BELL SYSTEM PRACTICES
Teletypewriter and Data Stations

ADDENDUM P34.307
Issue 1, October, 1963
AT&TCo Standard

28 PERFORATOR-TRANSMITTER-BASE

WIRING DIAGRAM

28D, E, F and K Perforator-Transmitter-Bases

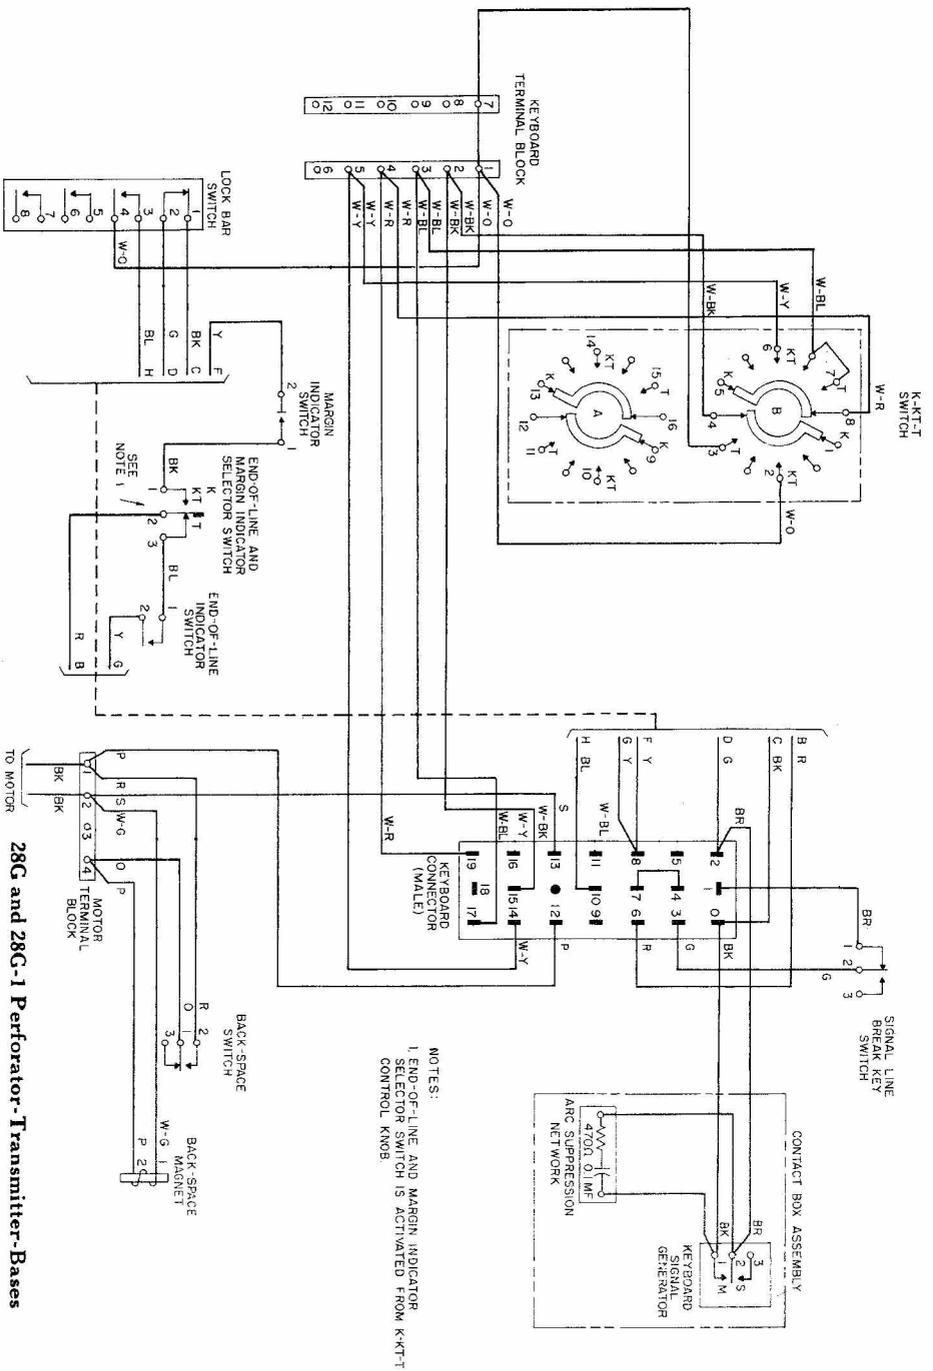
1.002 This addendum is issued to add the wiring for the 28G-1 and 28K perforator-transmitter-bases. The drawing showing the wiring for the 28D, 28E, 28F and 28K perforator-transmitter-bases was changed to (a) remove the jumper wire on the K-KT-T switch, (b) add a white-purple (W-P) wire from terminal 3 of the K-KT-T switch to terminal 7 of the keyboard terminal block and (c) add a jumper between terminals 1 and 7 of the keyboard terminal block.
